LETTER AND U S NAVY RESPONSE TO U S EPA REGION III COMMENTS TO DRAFT SITE  
INSPECTION REPORT SITE 7 OLD DUPONT DISPOSAL AREA FISC WILLIAMSBURG VA  
11/11/2012  
CH2M HILL

# Response to Comments

## Draft Site Inspection Report

### Site 7

Figure 22. York River shoreline erosion rates (meters/year) using CBP analysis of Hardaway and others (1992). Only mainstem reaches were used.

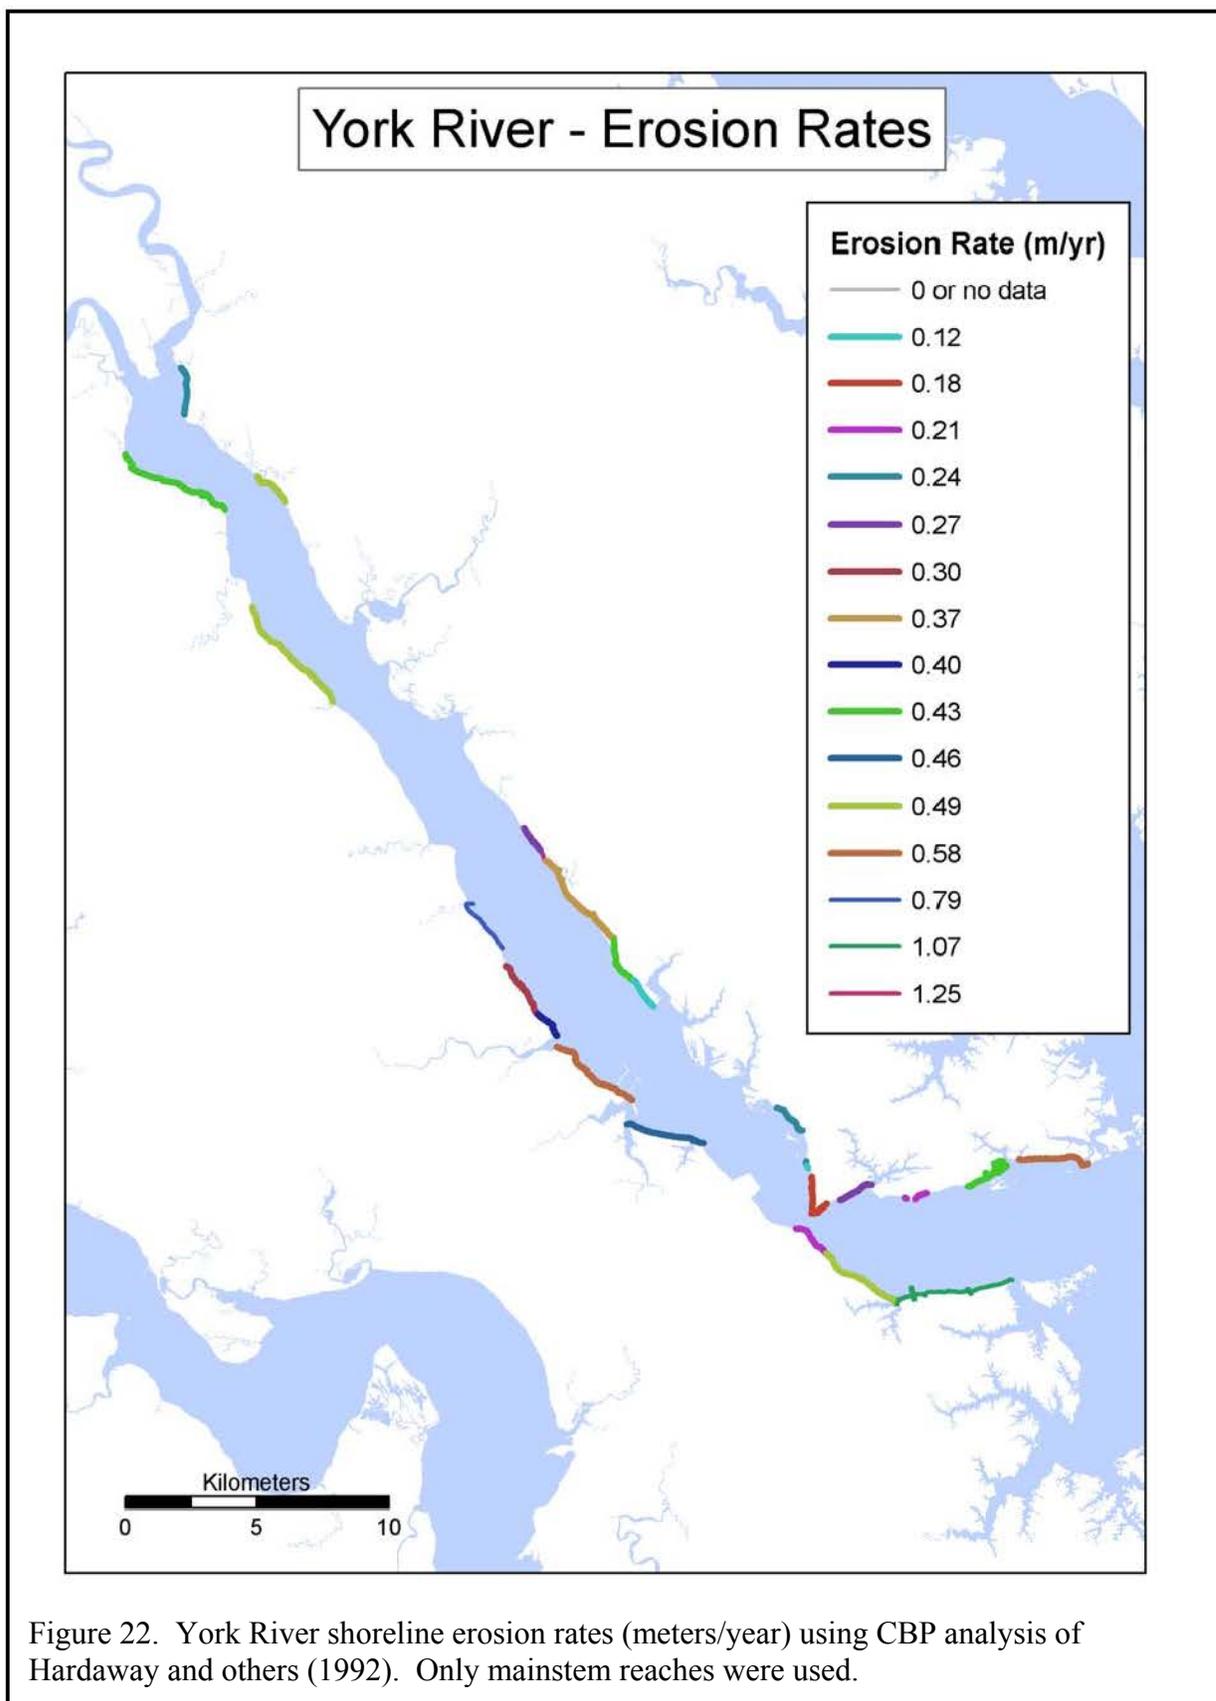
EPA BTAG Comment 22: *How much erosion occurs in the vicinity of this site? More information is needed to better define/support use of the term “unlikely.” The net loss of sediment needs to be quantified on an annual basis, such that the reader can have an idea of how much sediment (mm, cm lost each year) is transported out of the Site 7 vicinity?*

Response: According to the *Estuarine Suspended Sediment Loads and Sediment Budgets in Tributaries of Chesapeake Bay*, conducted by the Center for Coastal Resource Management (CCRM) and the Virginia Institute of Marine Science (VIMS) (CCRM & VIMS, 2010), the shoreline erosion rate in the vicinity of Site 7 is 0.58 meters per year (Attachment 1). The SI Report will be updated to include this information.
